**NORTH AMERICAN AVIATION • INC.**

SERVICE LETTER NO. 2

SUBJECT: PROPELLER CONTROL FRICTION LOCK

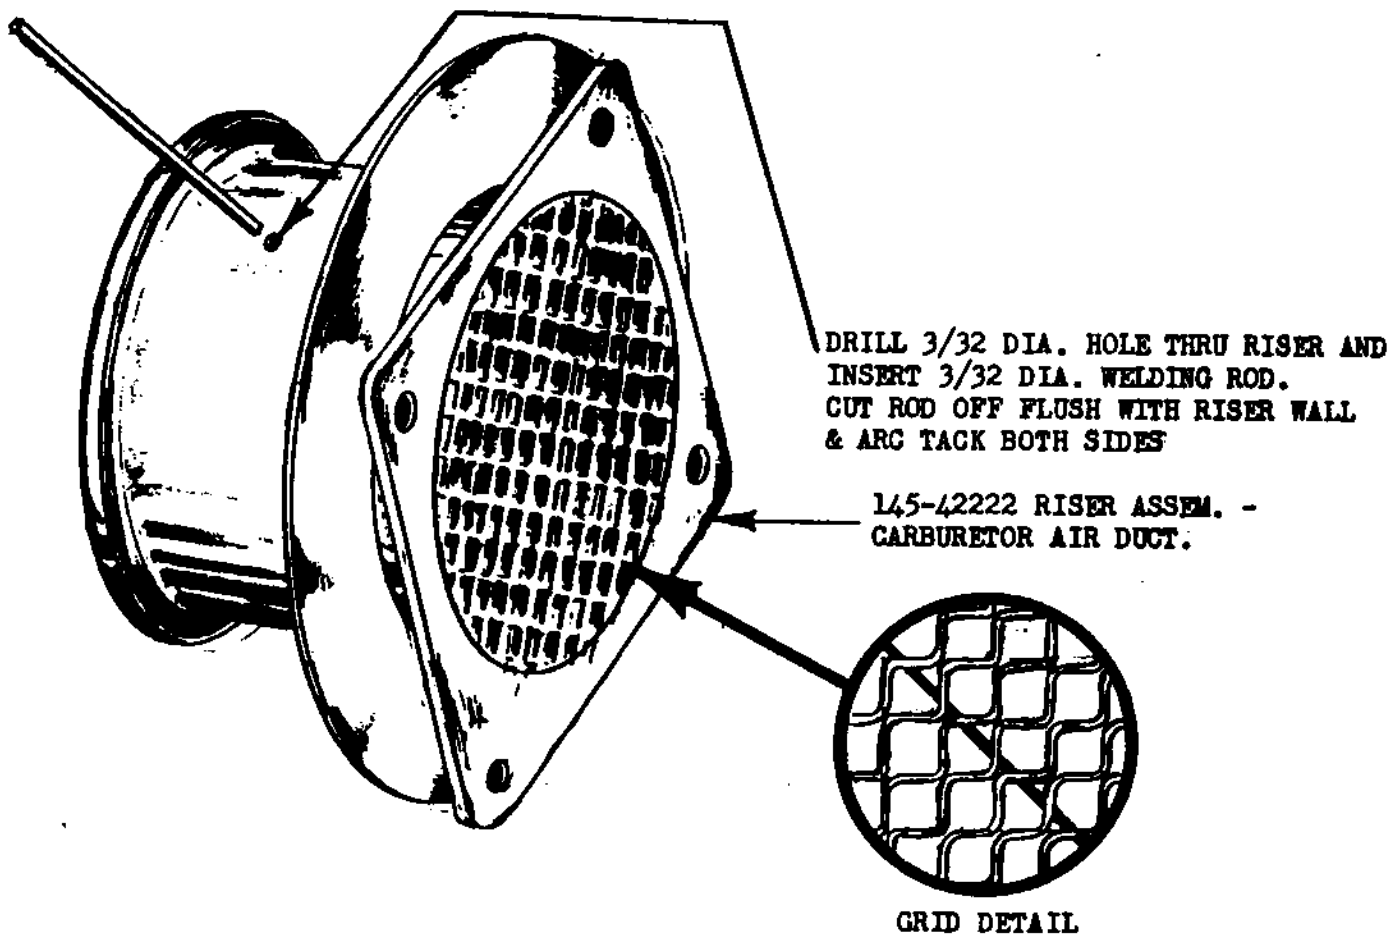
The Adel electrically driven fuel pump used on the Navion is composed of three parts; the motor housing; pump housing; and manifold. Tubing from the airplane attaches to these pumps on the manifold, while the pump mounts on the airplane by means of a mounting pad on the motor housing. This means the distance from the point of tubing attachment is several inches from the point at which the pump is mounted. It is therefore, very easy for a mechanic to create a twist between the manifold, pump housing and motor housing, at the time the tubing connector nuts are being tightened. It is very essential that this turning, or twisting action be eliminated, by securely holding the manifold housing while the tubing nuts are being tightened.

It is obvious that if a misalignment is created by the act of tightening the tubing nuts, the entire unit could be put into such a bind that it would fail to operate. Upon disassembly of the unit, in order to return it to Adel, the opposite twisting action takes place, thereby relieving the bound up condition of the pump and the pump tests as if it were perfectly O.K.

We are therefore requesting you to instruct your mechanics to securely hold the body of the manifold, while the tubing connections are being tightened.

**REFERENCE: NAVION SERVICE MANUAL FIGURE 21**

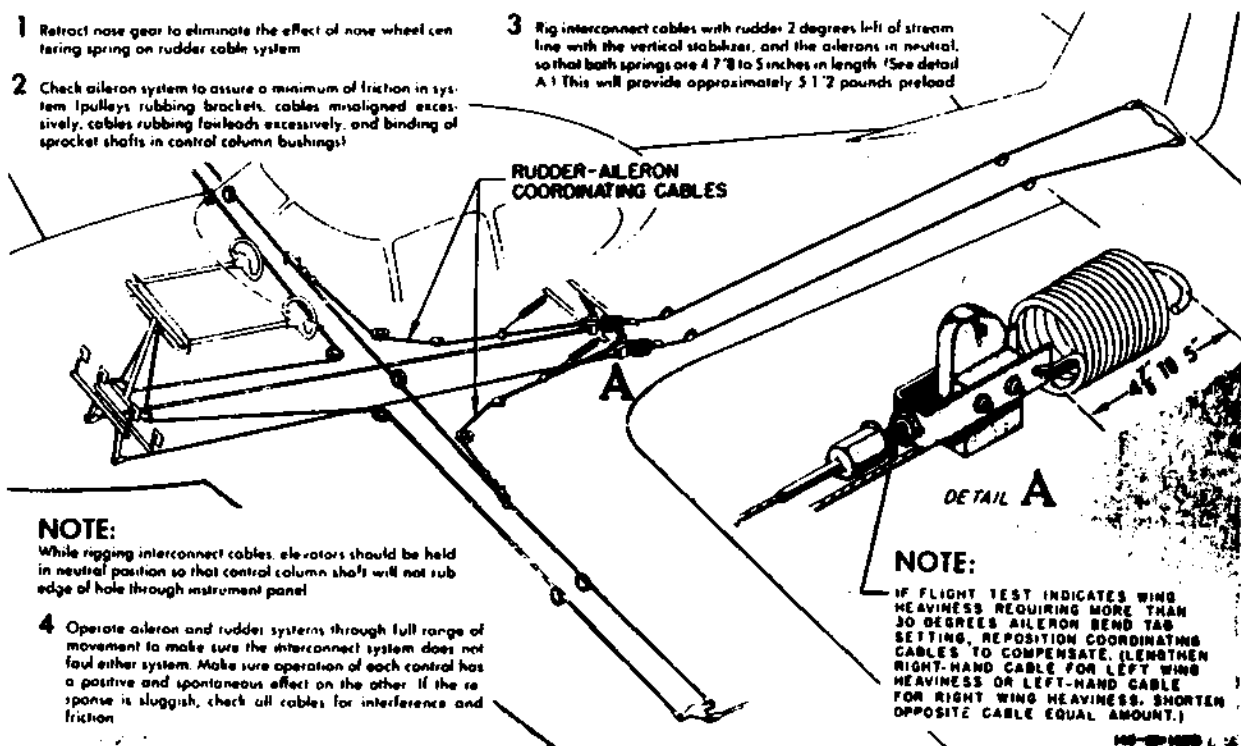
In the Navion Service Manual, all editions, Figure 21, showing the installation of the Aileron-Rudder interconnect cable is in error. The illustration shows the interconnect cable attaching to the wrong aileron cable. Though this cannot happen in practice, as the aileron cable shown has no provisions for attaching the interconnect cable, a revised illustration is provided below. Please paste this illustration over existing illustration in your manual.

FIG. NO. 1 SERVICE LETTER NO. 89

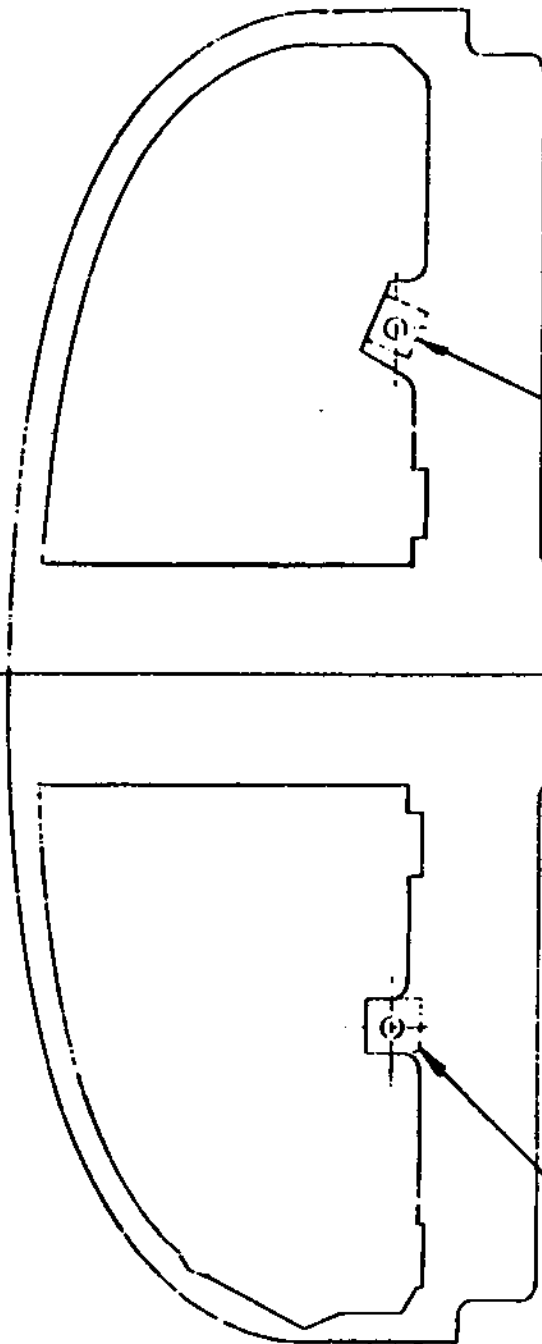
14531003-0 FAIRLEAD  
DRILL OUT EXISTING RIVET HOLES  
TO # 20 (.1405) DIA. AND ATTACH  
FAIRLEADS WITH AN 526-632E4  
SCREWS AND AN 964-632 NUTS.

Figure 1 - Accumulator Tank Bracket

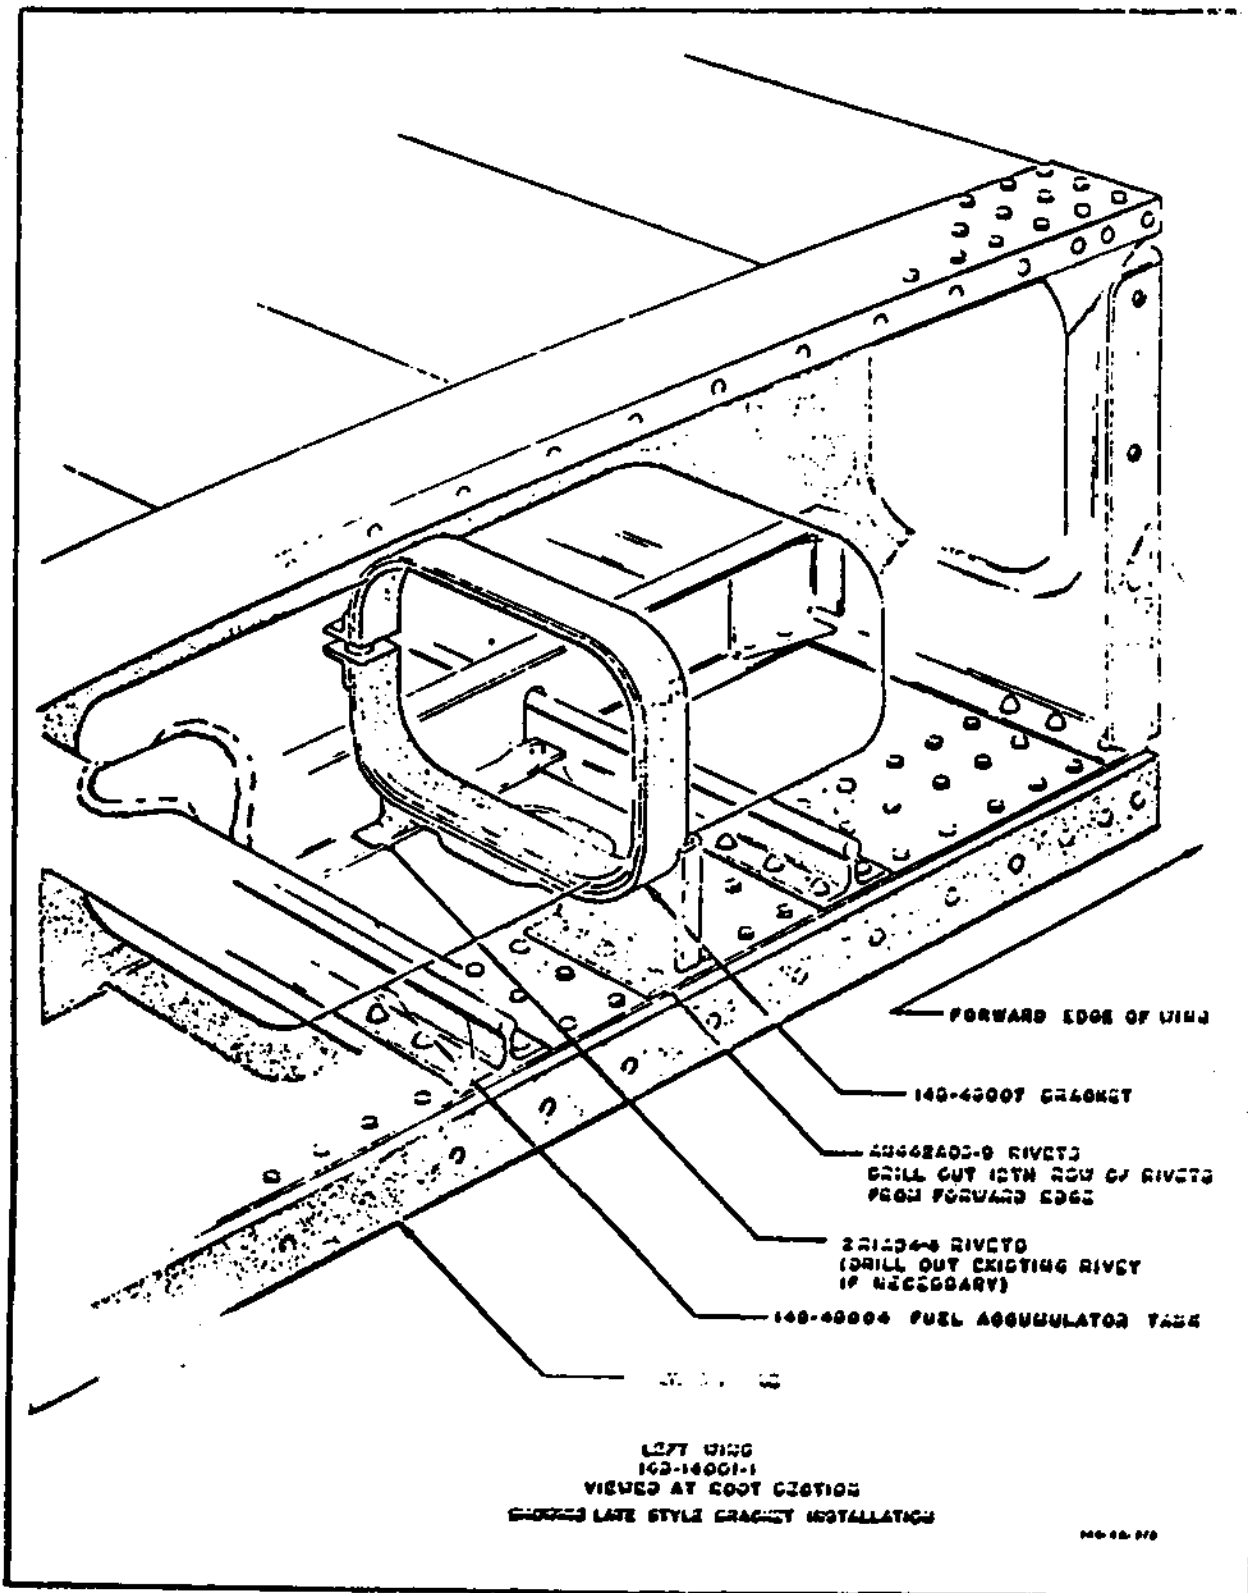
1. Inspect the inside root section of left wing to see if the 145-48007 fuel accumulator tank bracket is installed. If bracket is not present, install the new 145-48007 bracket, received as a loose part, as follows:
  - a. Drill out three AN442AD5-8 rivets which run spanwise in the bolting angle. This is the 12th row of rivets aft of the forward edge of wing.
  - b. Clamp 145-48007 bracket in the wing with the flange of bracket over holes just drilled. Drill through bolting angle holes and bracket flange with a No. 21 (.159) drill.

CAUTION: Do not elongate holes in bolting angle.
  - c. Attach bracket to bolt angle with three AN442AD5-9 rivets.
  - d. Drill through rib, wing skin, and pilot hole on outboard flange of bracket with No. 30 (.128) drill, and install one 2R1AD4-4 rivet.
